**ADDENDUM NO. 3
NEW ELEVATOR
AT MURPHY ELEMENTARY SCHOOL
ROUND LAKE SCHOOL DISTRICT NO. 116
PROJECT NO. 23170**

Board of Education
Round Lake School District 116
884 West Nippersink Road
Round Lake, Illinois 60073

This Addendum shall be part of the Specifications & Requirements for this project and shall be part of the actual contract document to complete the work. There are four (4) items in this Addendum.

E1.1

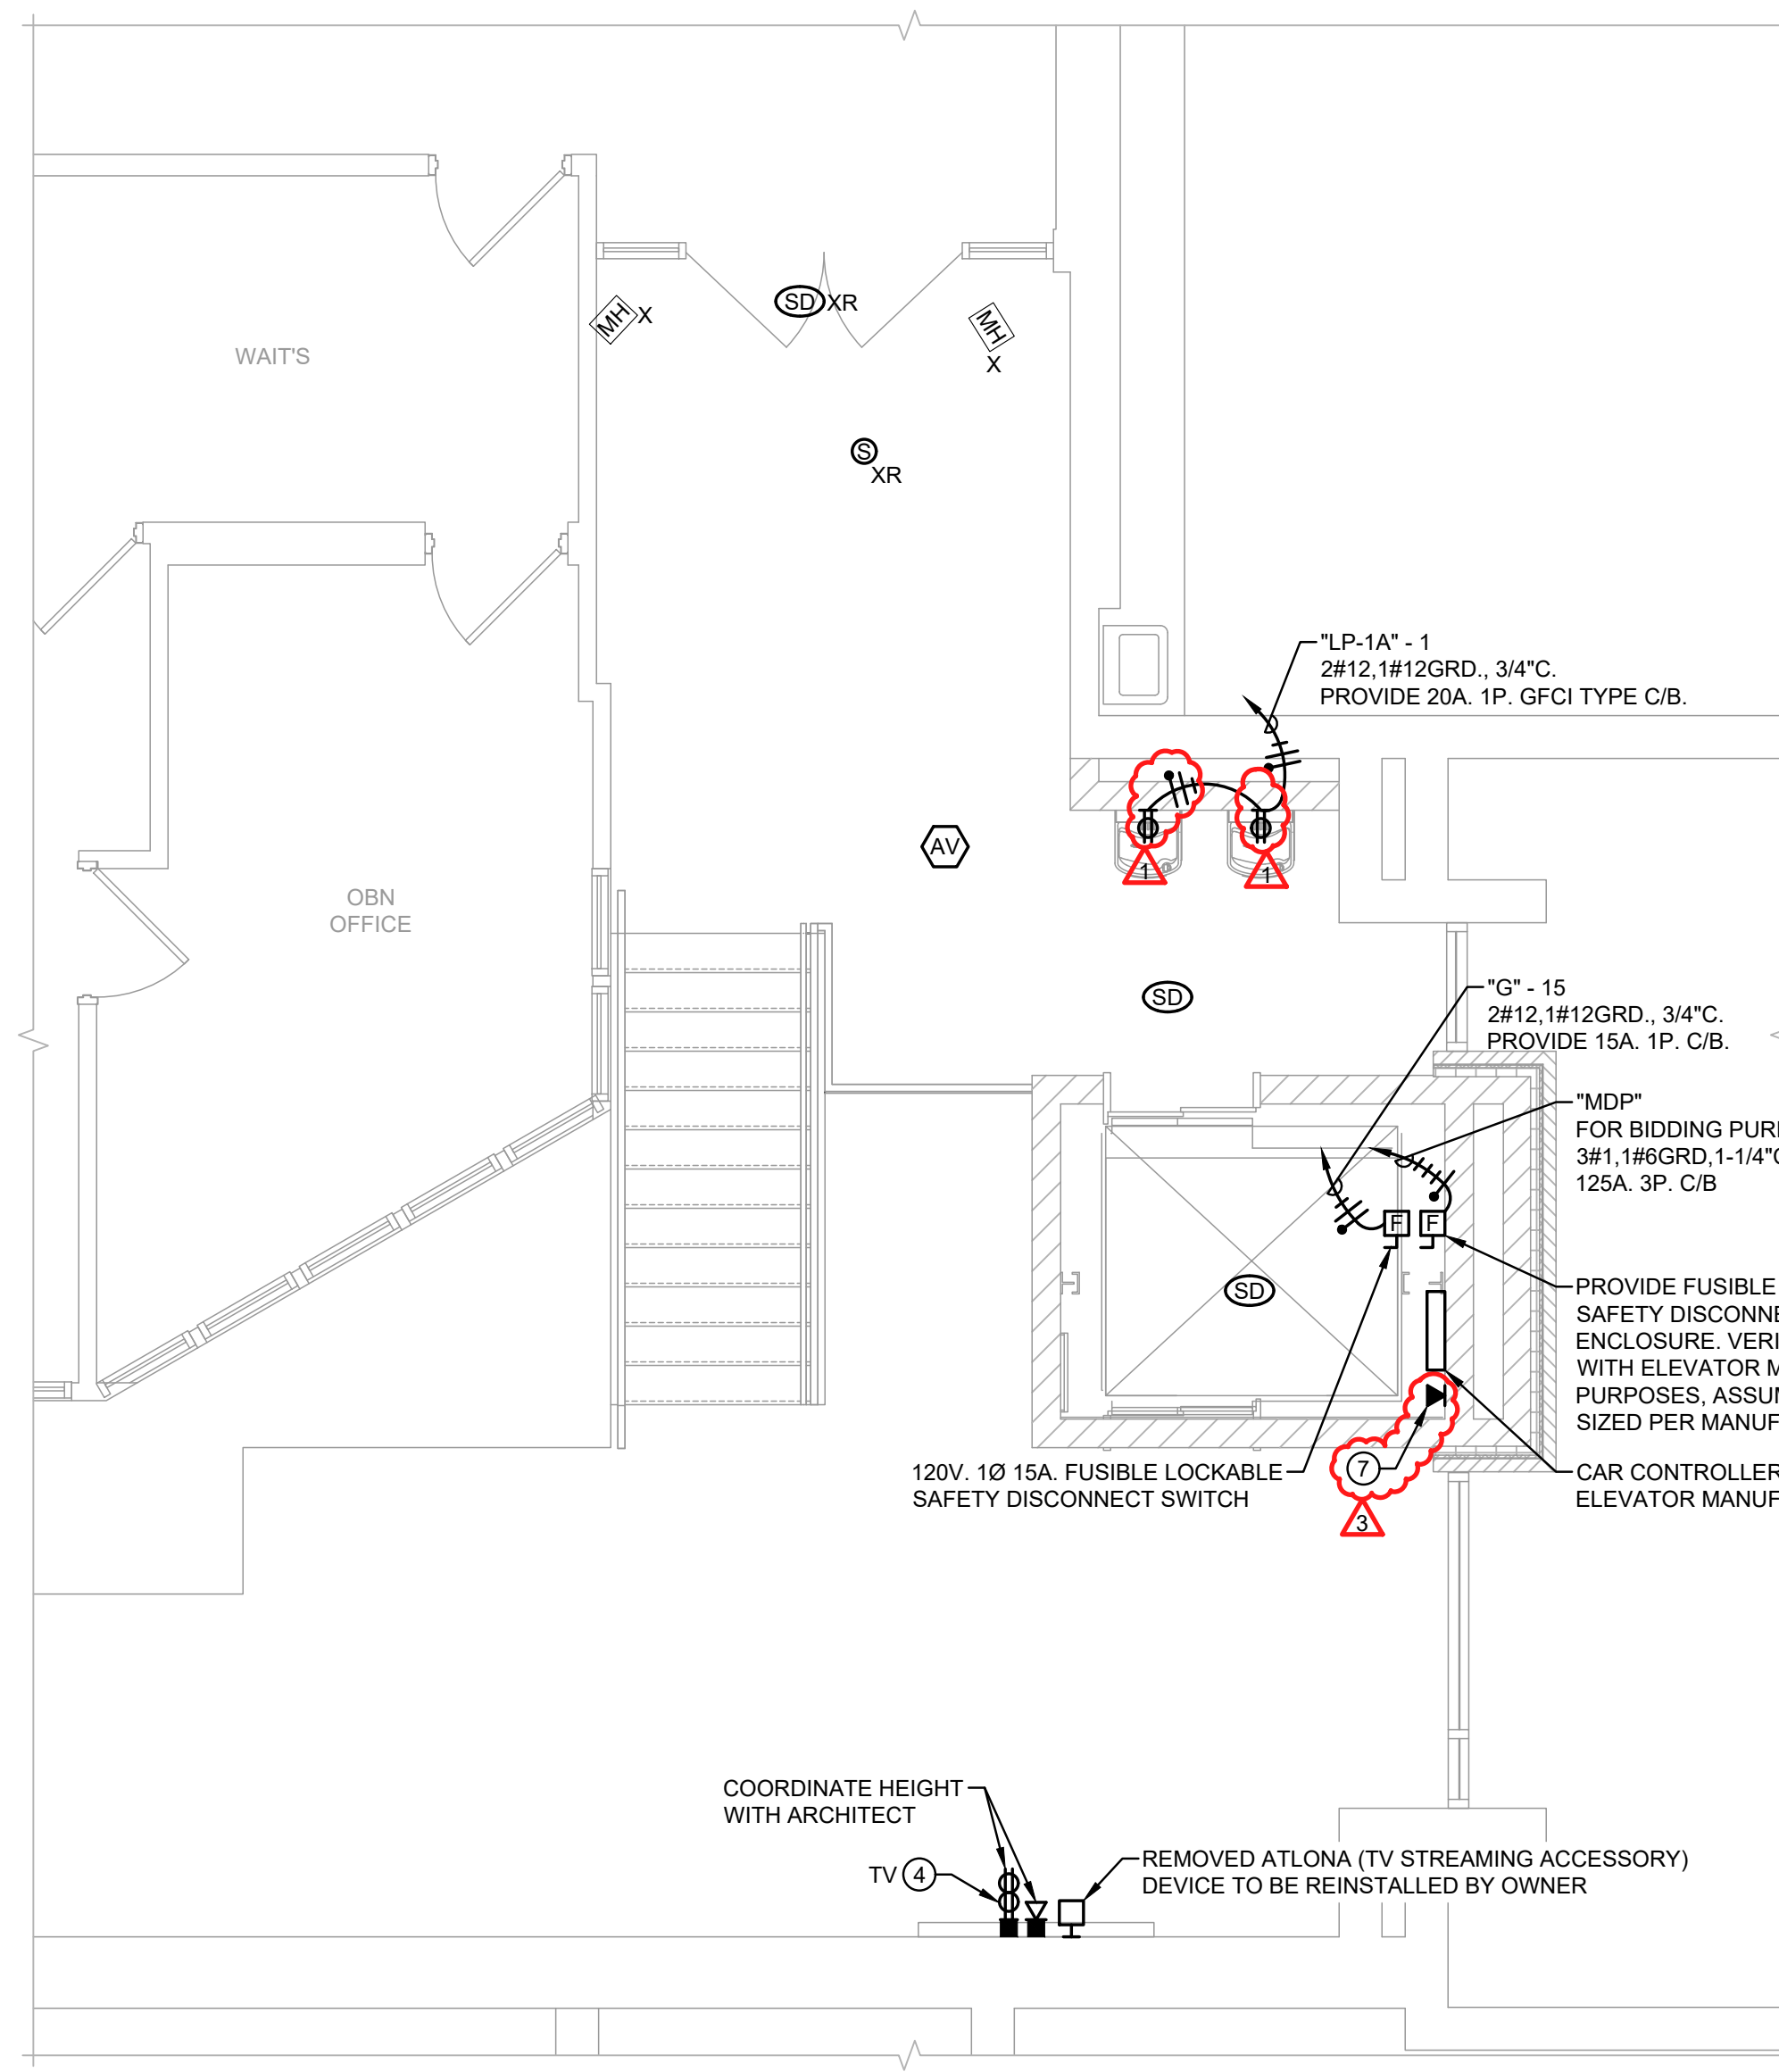
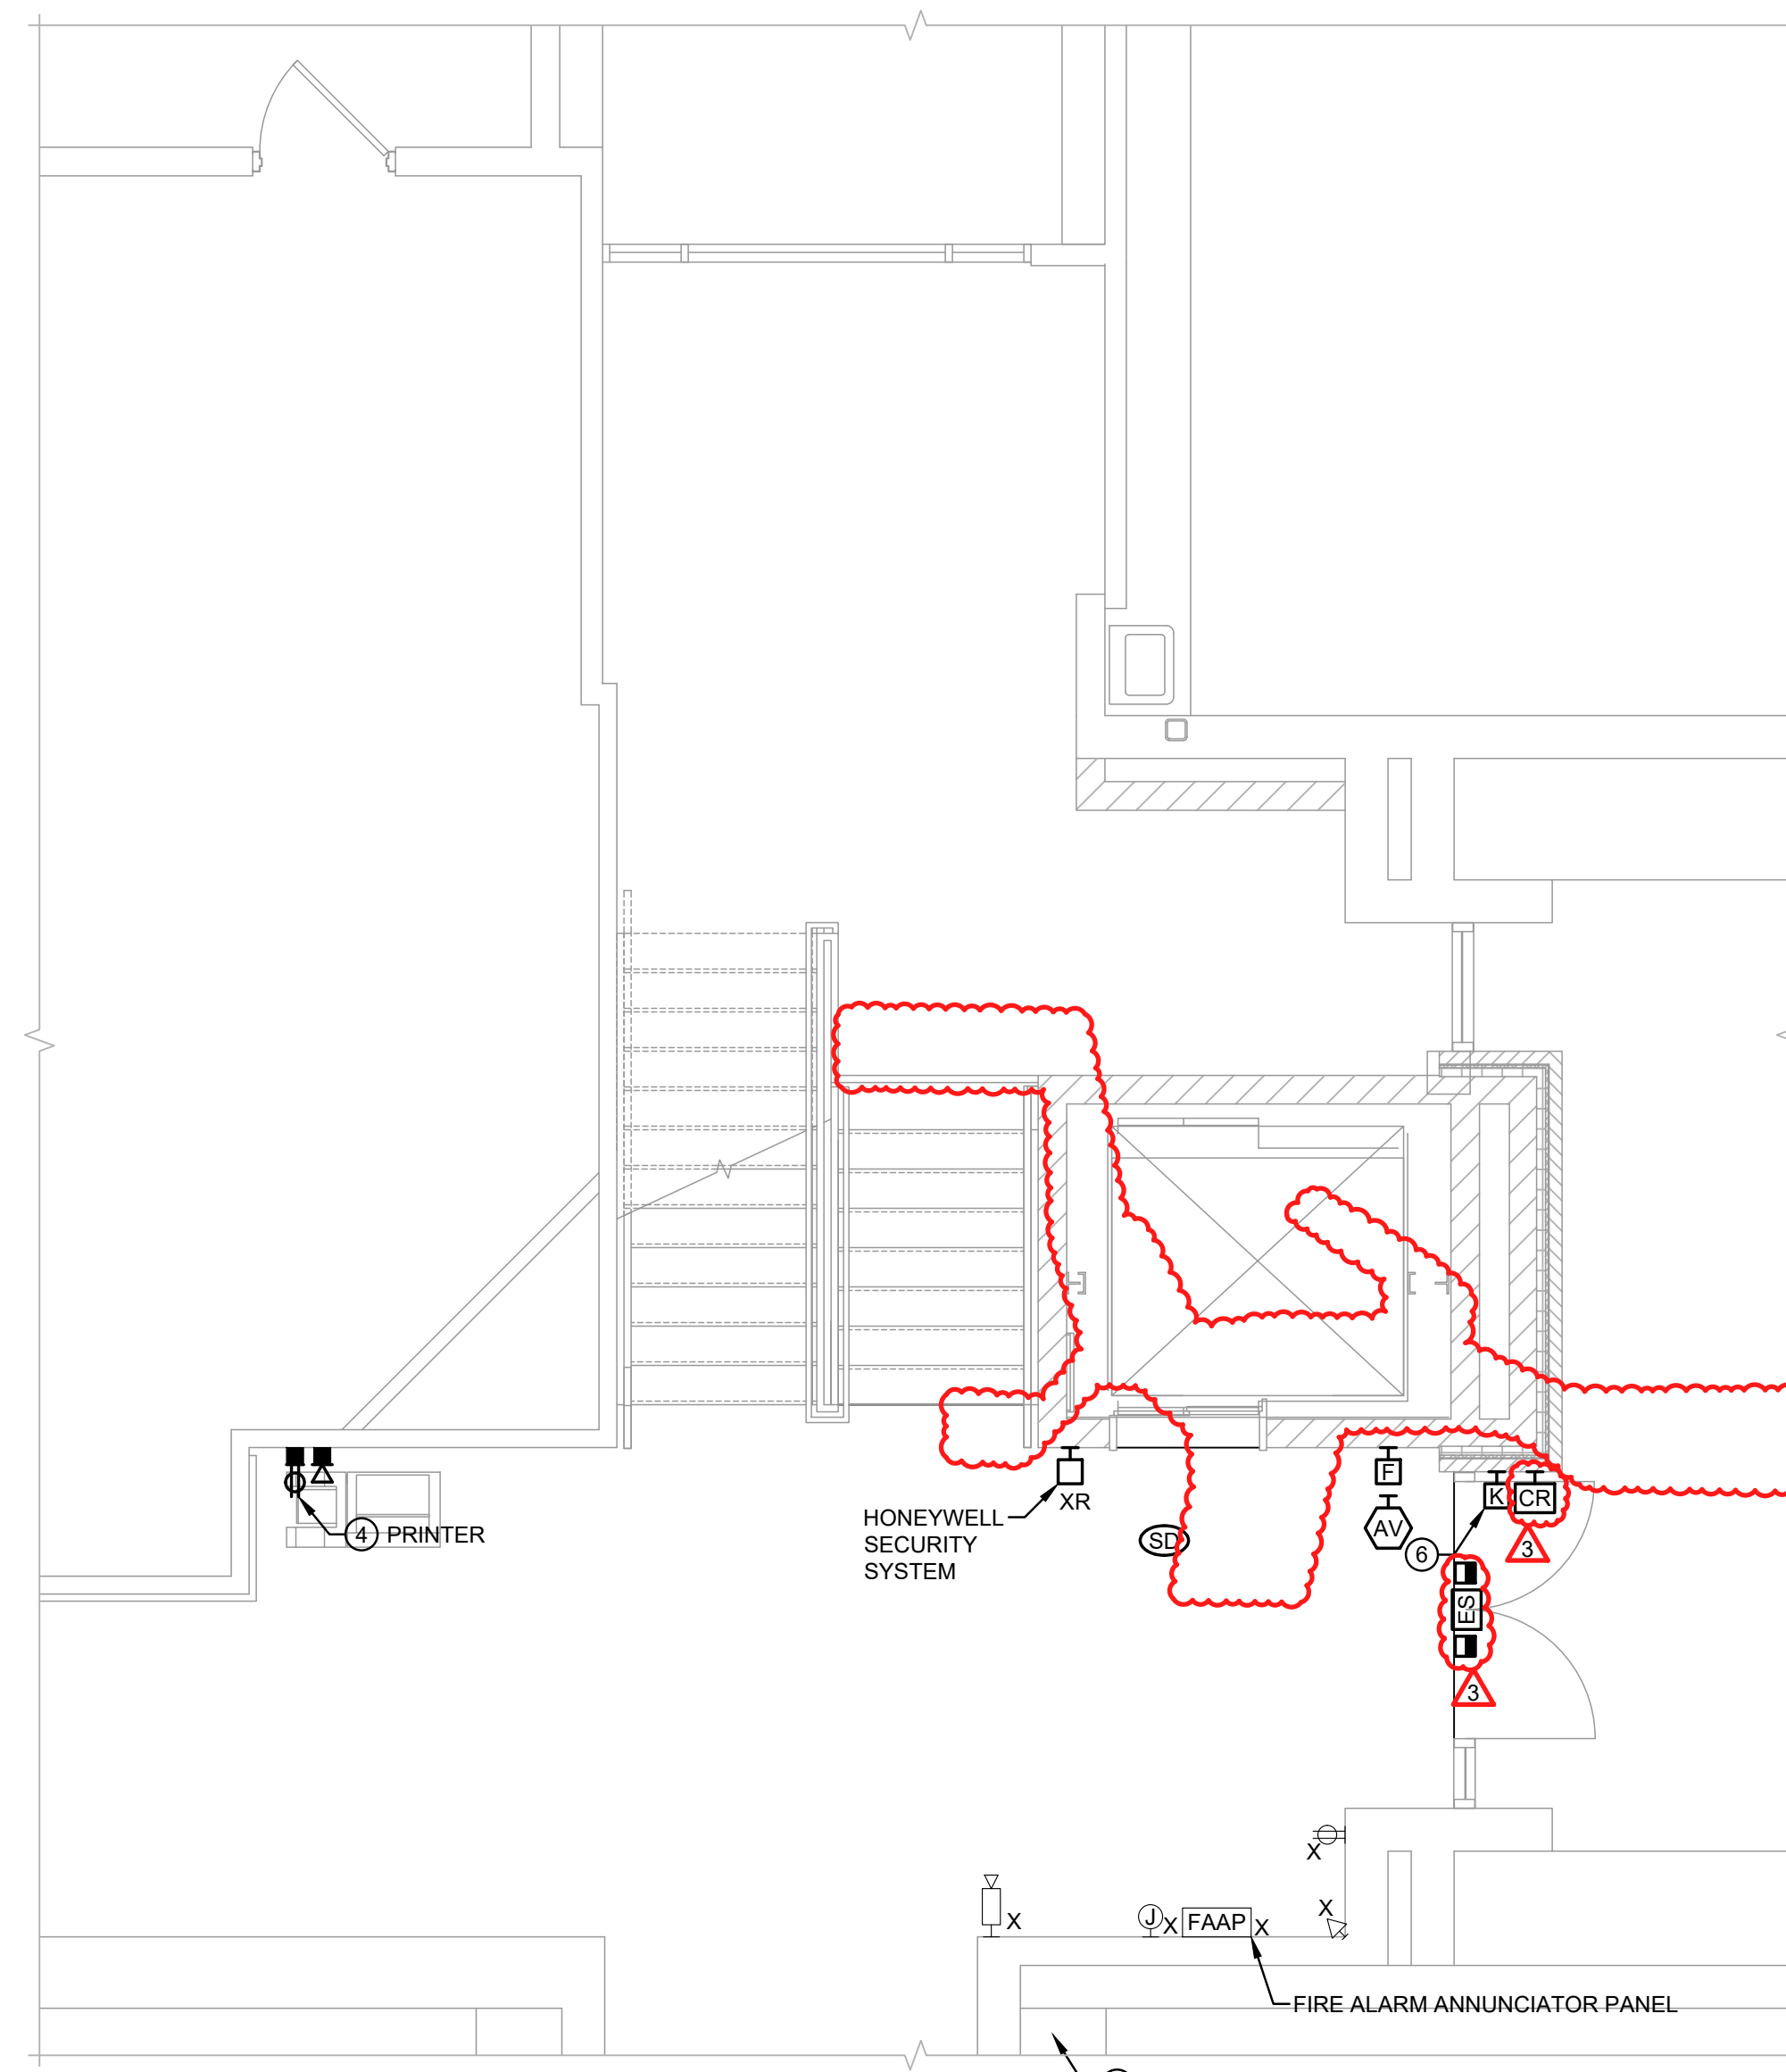
ITEM NO. 4: DRAWINGS, SHEET E1.1, PARTIAL ELECTRICAL PLANS

1. Add electric strike, two (2) door contacts, and exterior card reader for exterior door on Partial First Floor Electrical Plan.
2. Add note to drawing to say "EC to provide rough-ins for access control devices. EC to sub-contract devices and wiring to NTI"
3. Add phone connection to elevator in Partial Upper Floor Electrical Plan with note to say "Dedicated POTS or digital POTS connection. Verify connection type with elevator manufacturer and owner. Verify Exact location prior to rough-in."
4. Move submersible pump "SP-1", Electric Finned Tube "EFT-1", 2 pole disconnect switch, duplex GFCI type receptacle, and simplex receptacle from the First Floor Electrical Plan to the Lower Floor Electrical Plan.
5. Refer to attached drawing E1.1 and refer to highlighted items for updates.

- DEDICATED POTS OR DIGITAL POTS CONNECTION. VERIFY CONNECTION TYPE WITH ELEVATOR MANUFACTURER AND OWNER. VERIFY EXACT LOCATION PRIOR TO ROUGH-IN.

EC TO PROVIDE ROUGH-INS FOR ACCESS CONTROL DEVICES. EC TO SUB-CONTRACT DEVICES AND WIRING TO NTI.
